PHOTO 4

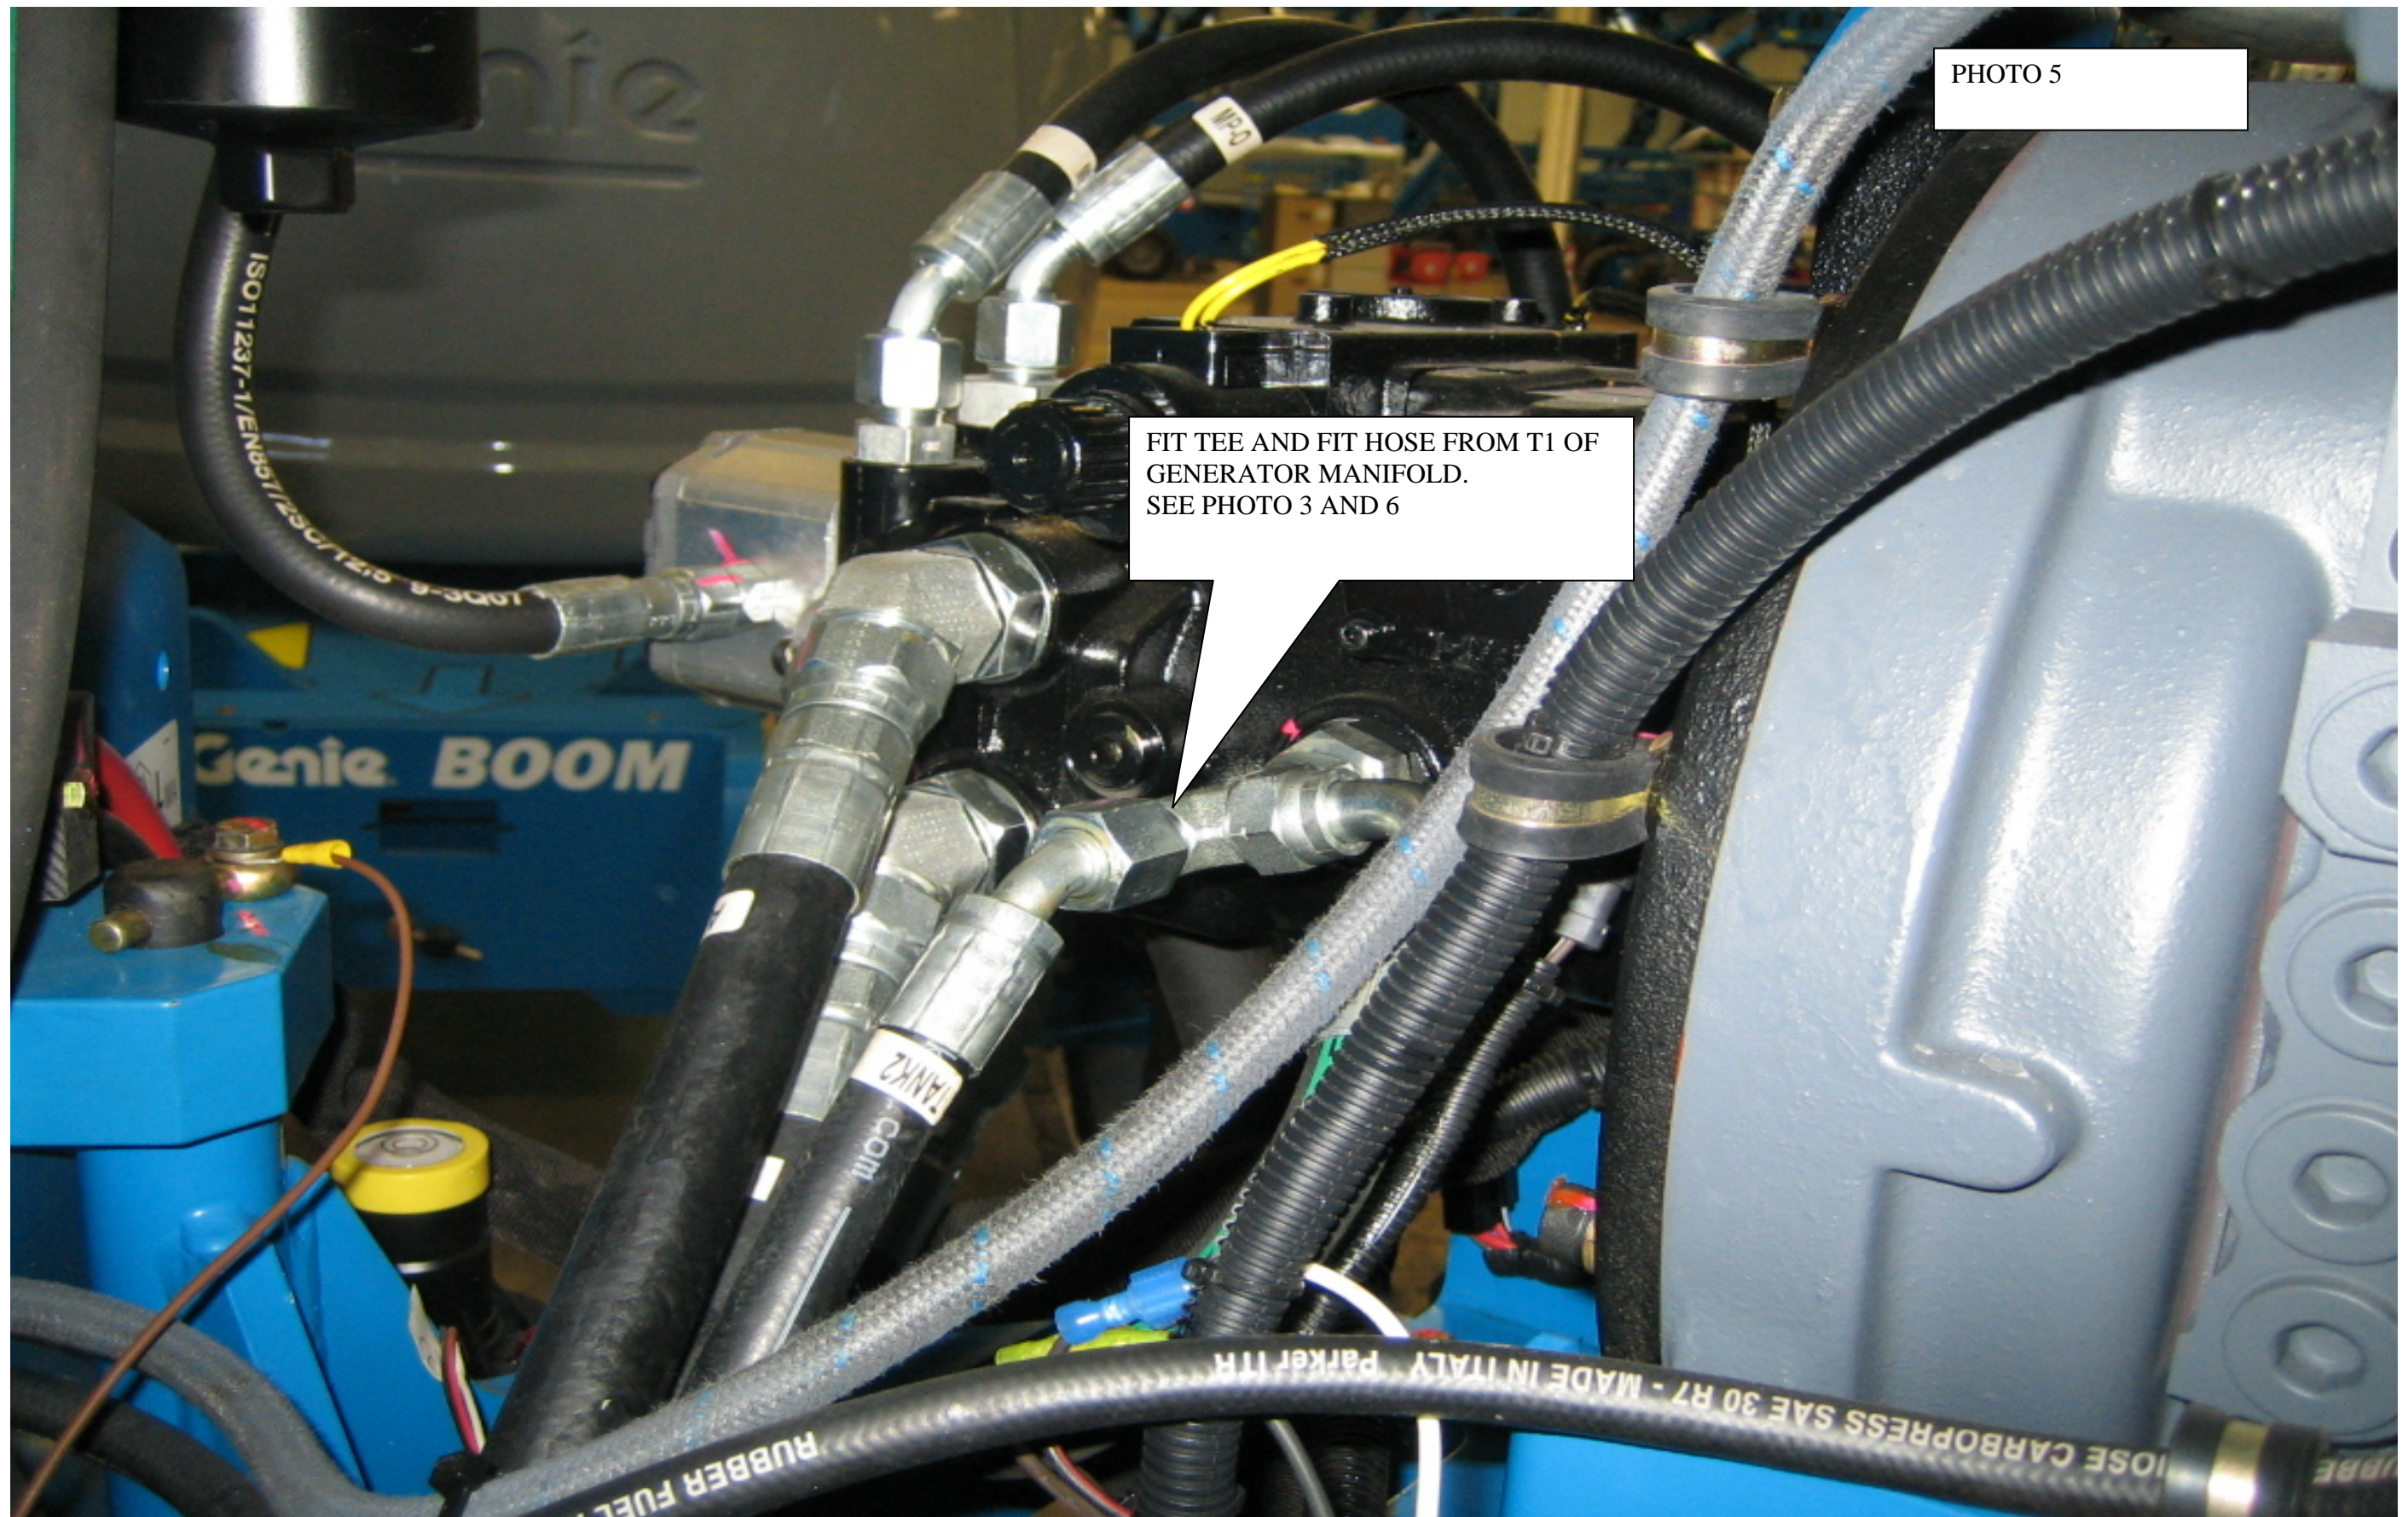
REMOVE THIS HOSE AND
FIT TO P2 ON GENERATOR
MANIFOLD. FIT NEW
HOSE FROM HERE TO P1
ON GENERATOR
MANIFOLD.
SEE PHOTO 3

PHOTO 3

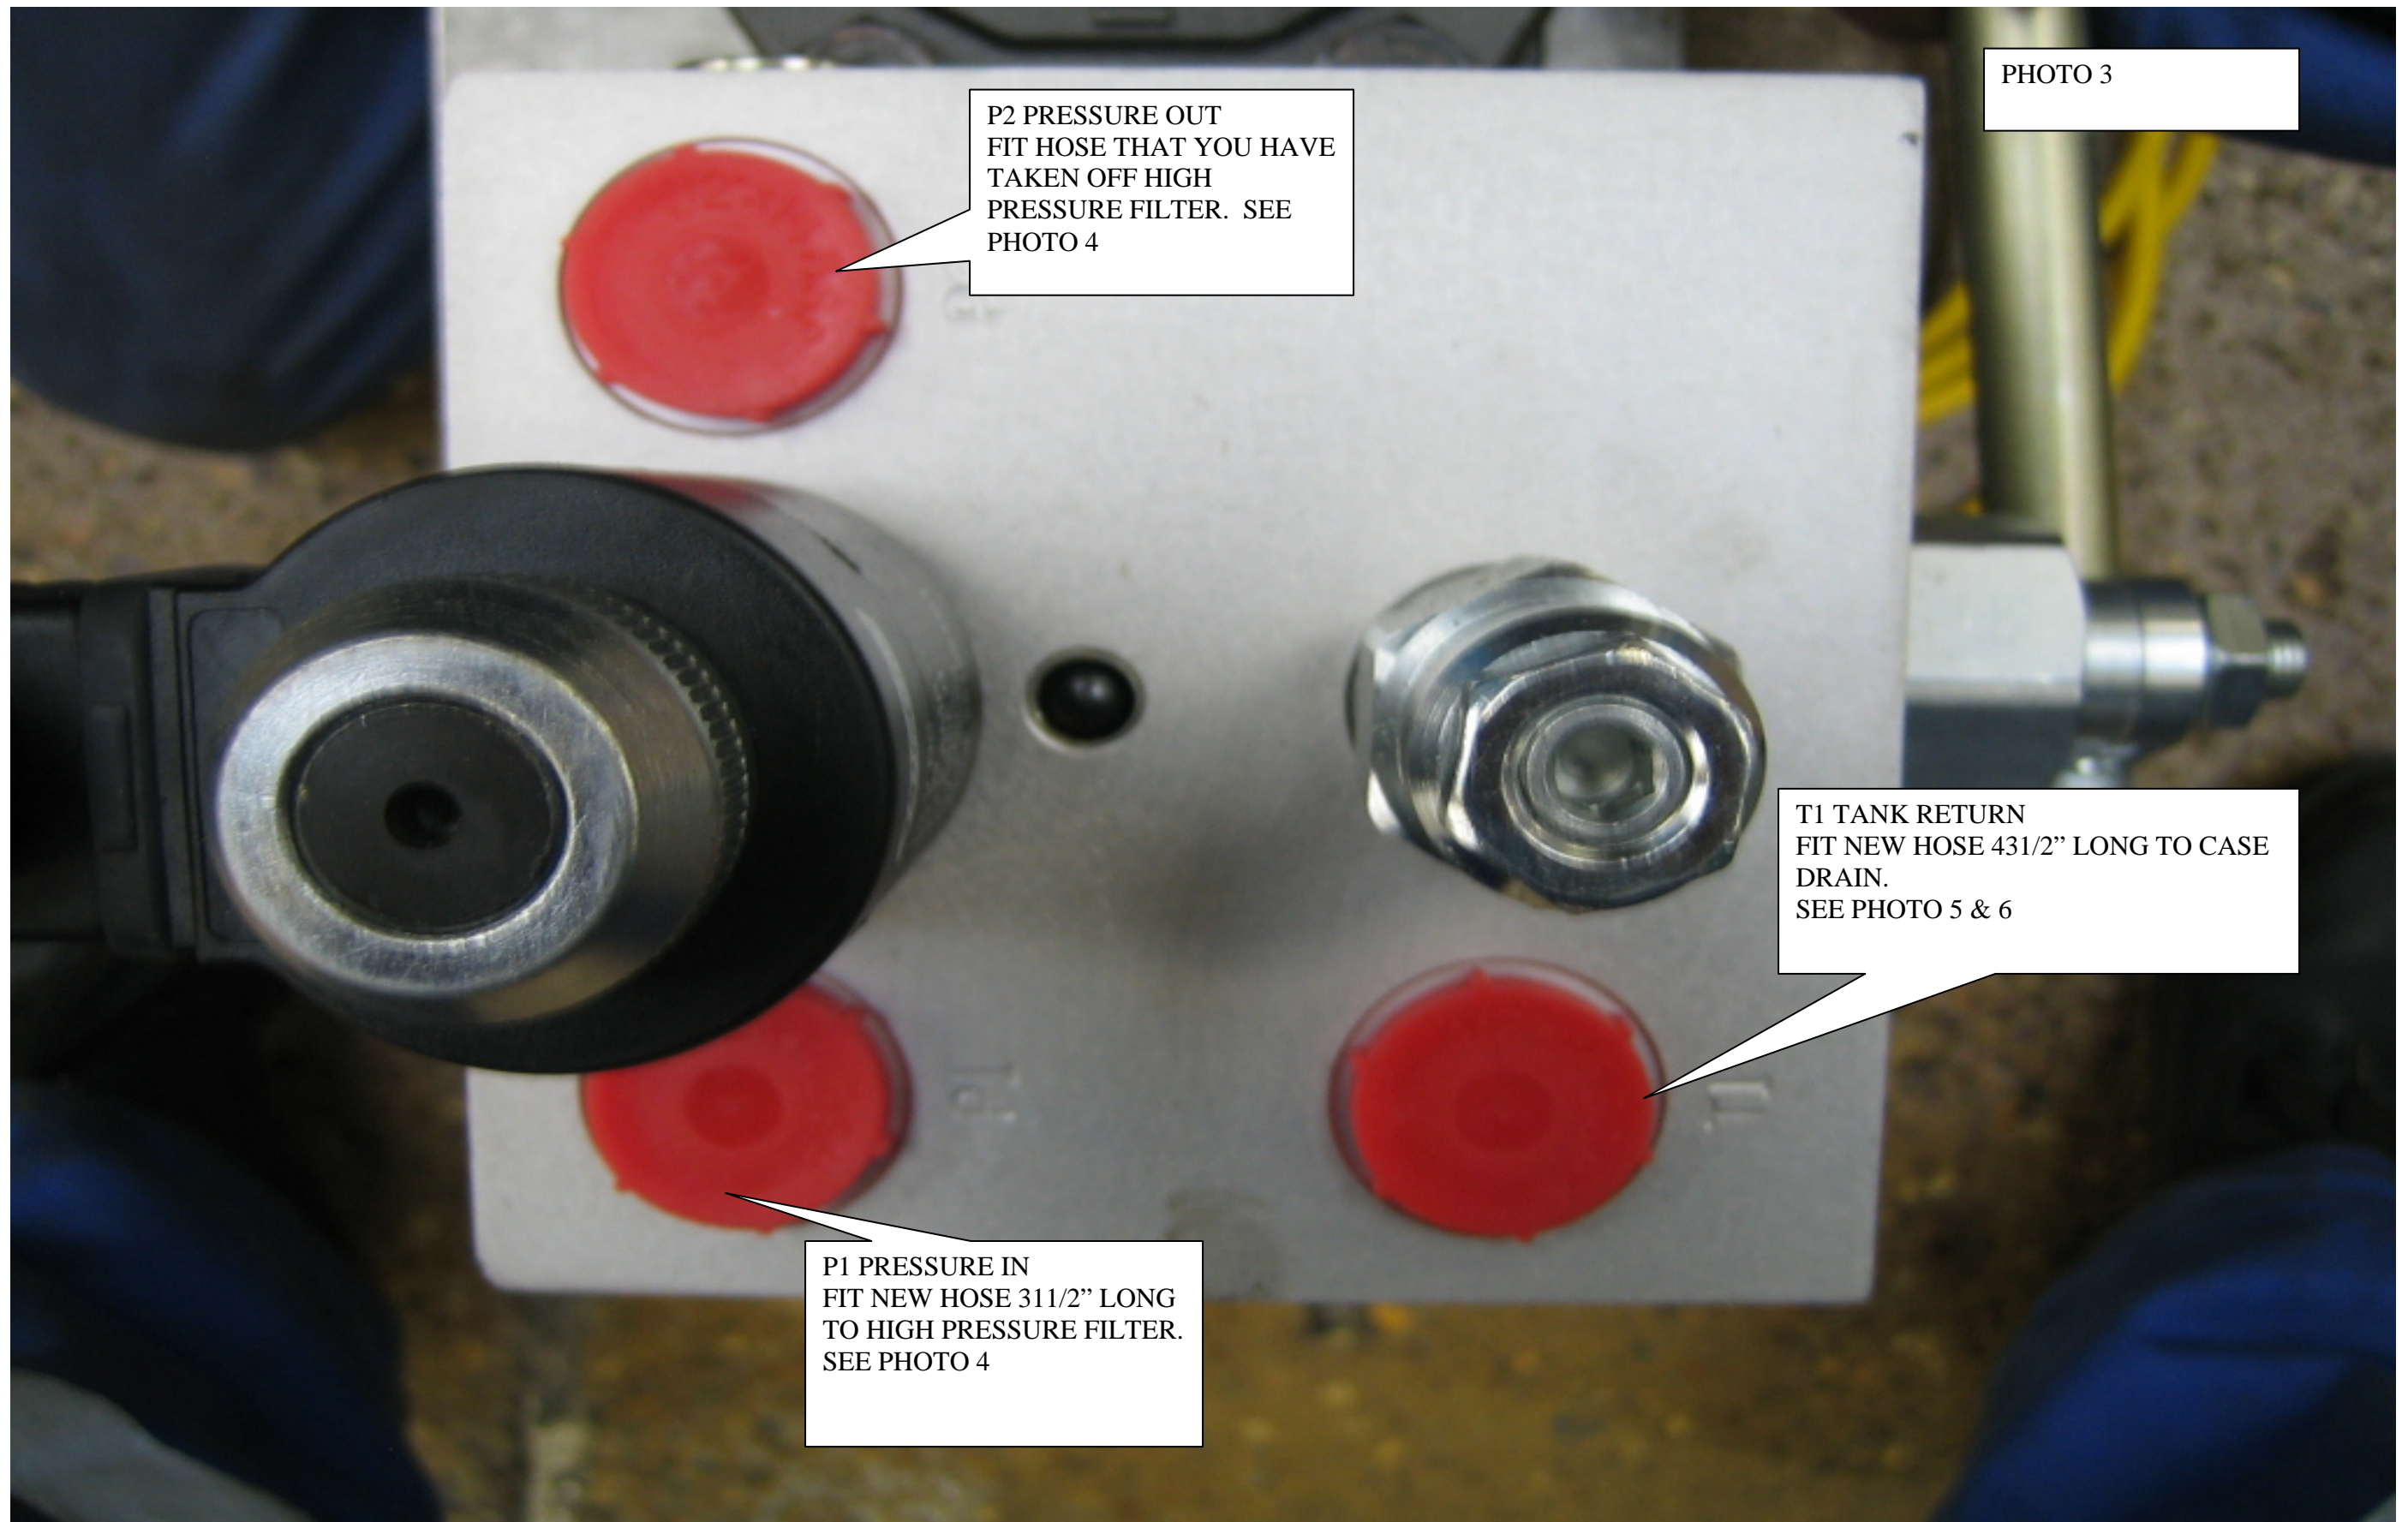
P2 PRESSURE OUT
FIT HOSE THAT YOU HAVE
TAKEN OFF HIGH
PRESSURE FILTER. SEE
PHOTO 4

T1 TANK RETURN
FIT NEW HOSE 43 1/2" LONG TO CASE
DRAIN.
SEE PHOTO 5 & 6

P1 PRESSURE IN
FIT NEW HOSE 31 1/2" LONG
TO HIGH PRESSURE FILTER.
SEE PHOTO 4

PHOTO 6

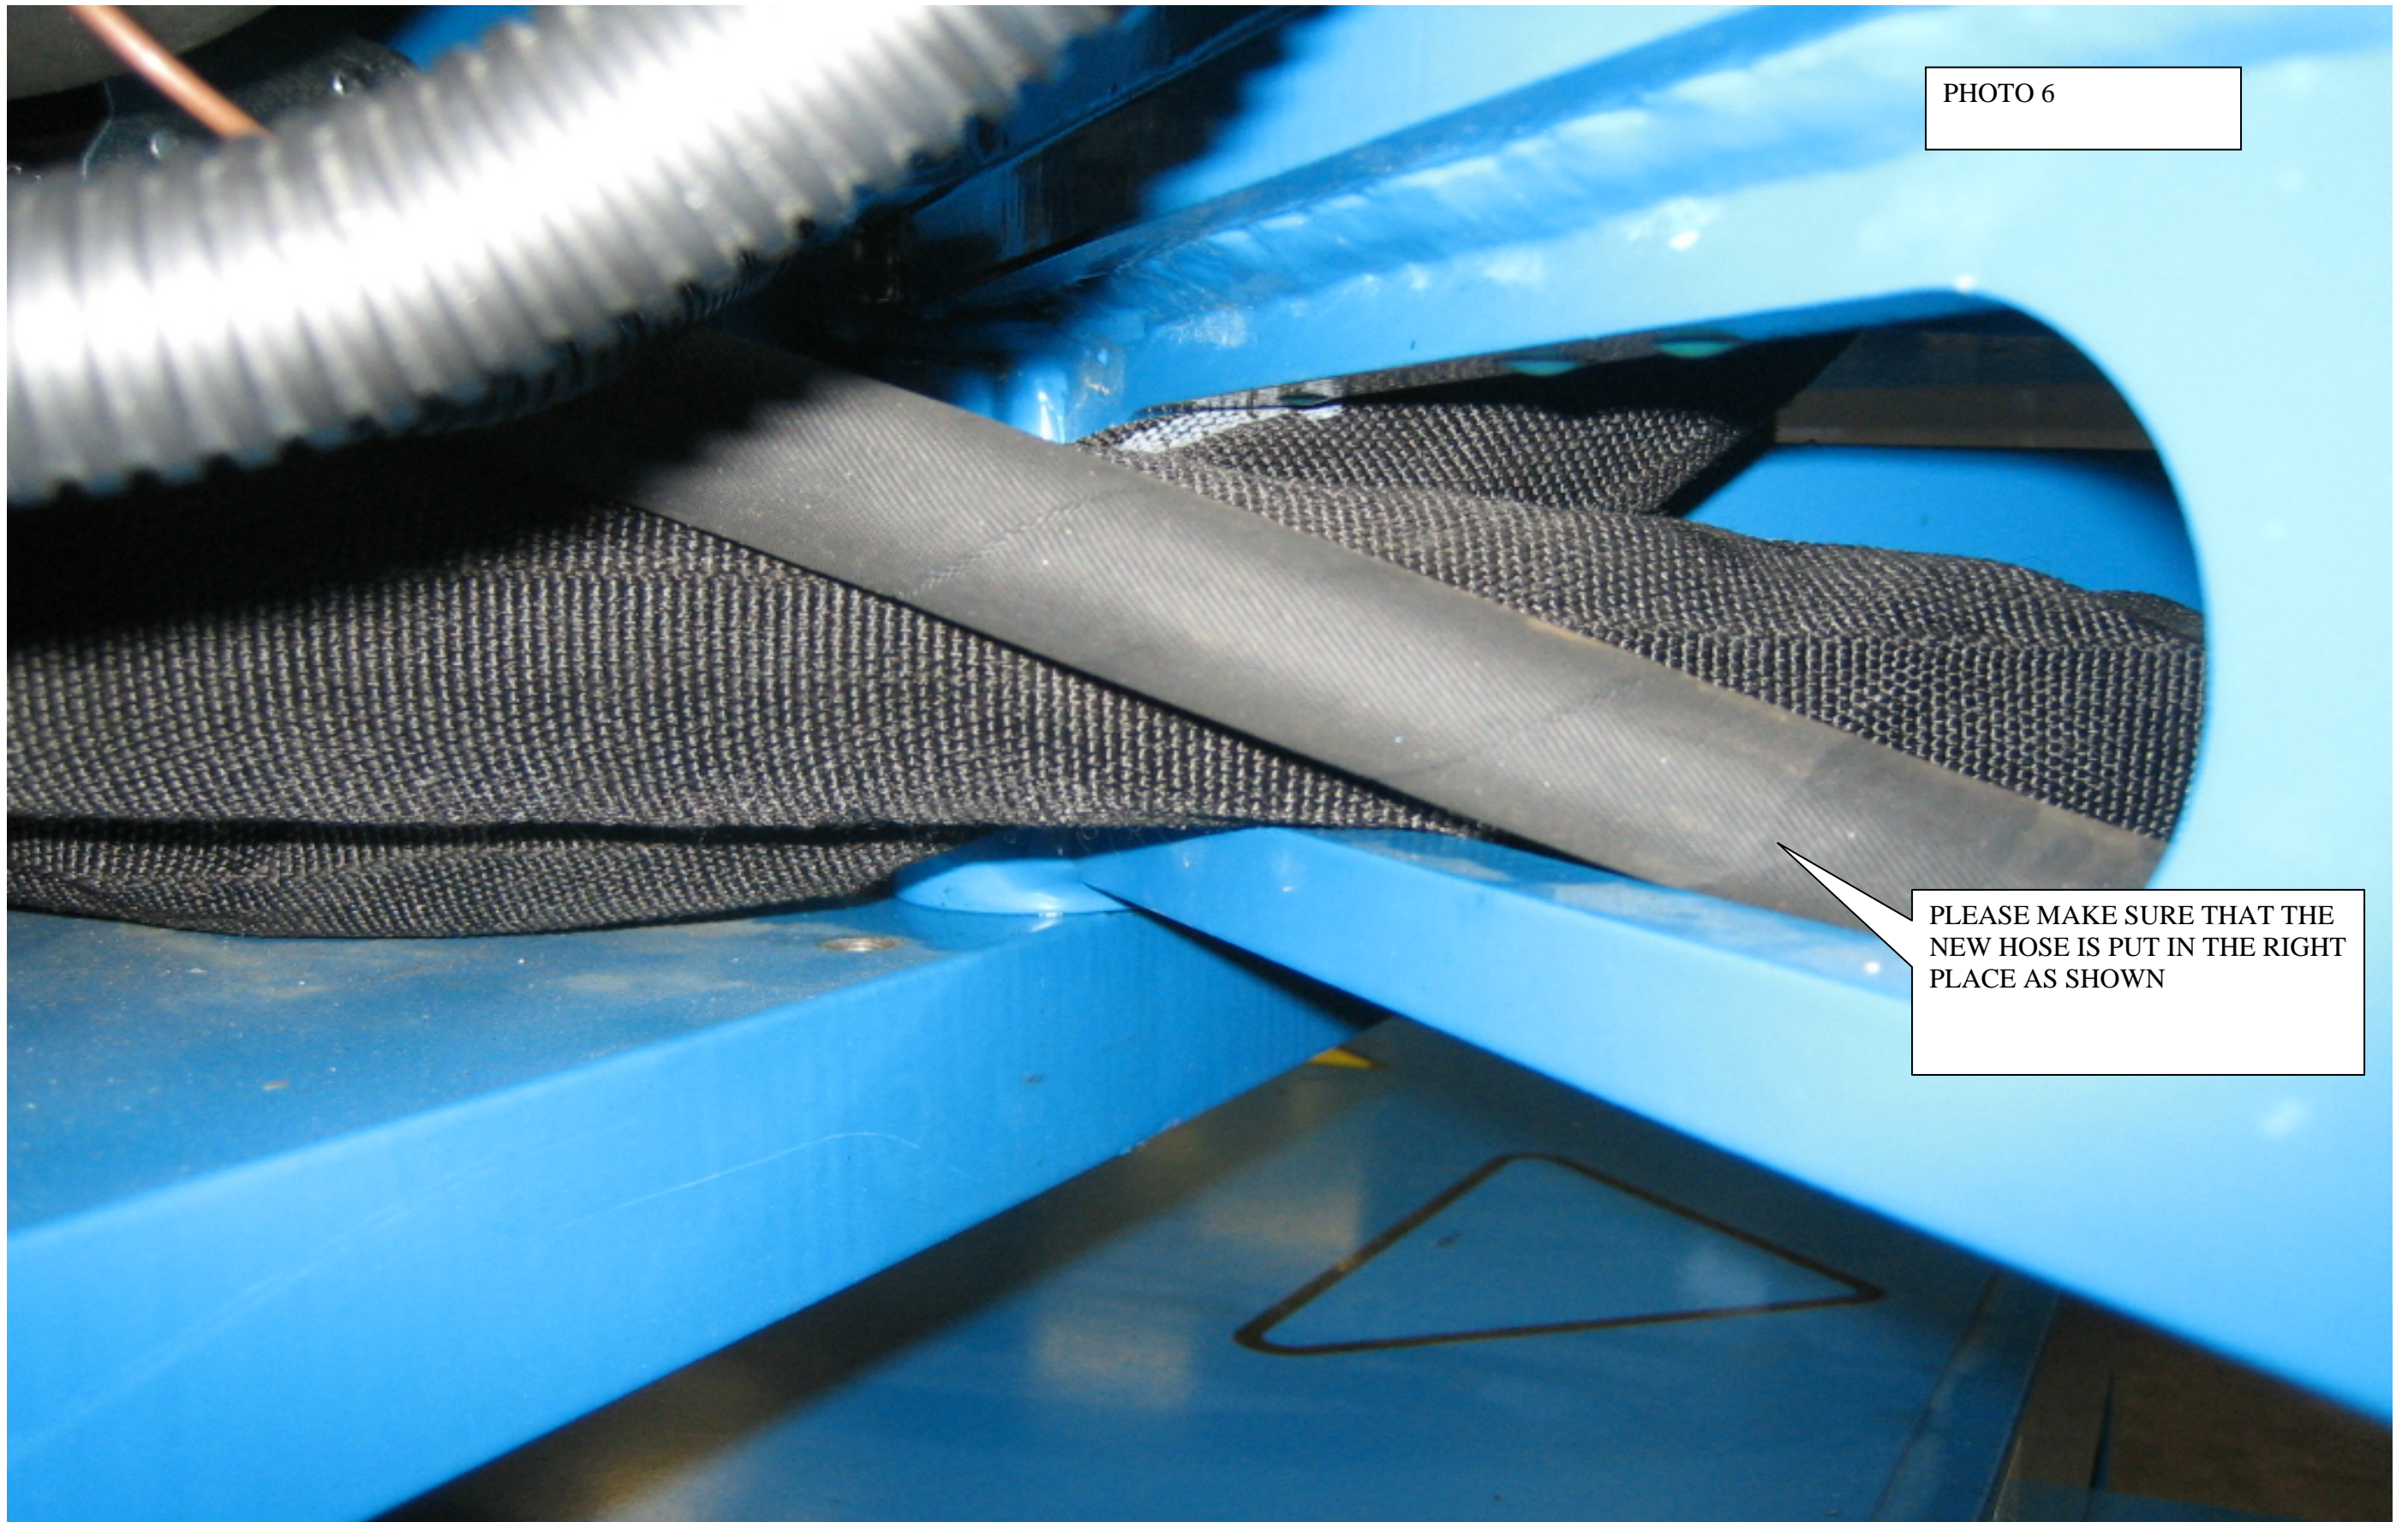
PLEASE MAKE SURE THAT THE
NEW HOSE IS PUT IN THE RIGHT
PLACE AS SHOWN
